**Report: Issue Report
Function: Test, Adjust, & Balance
Date: 09/19/2022**

**PROJECT
09-19 CULVERS - LOGANSPOORT, IN**

Project Issue Information

Issue Name : CONDUIT FOR PRV1 is tight.

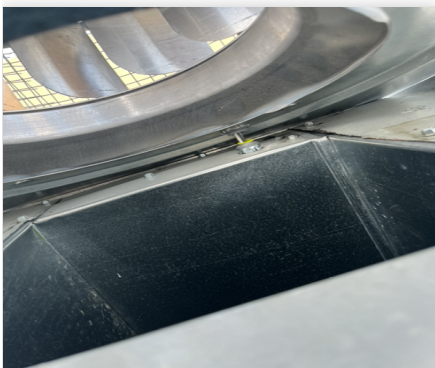
Description : When you lean the exhaust fan back or try to remove it you can not lift it more then 2-3 inches. Looks like the wires will rip or short out if the fan is pulled back too far. This also may be why backdraft damper is not yet installed.
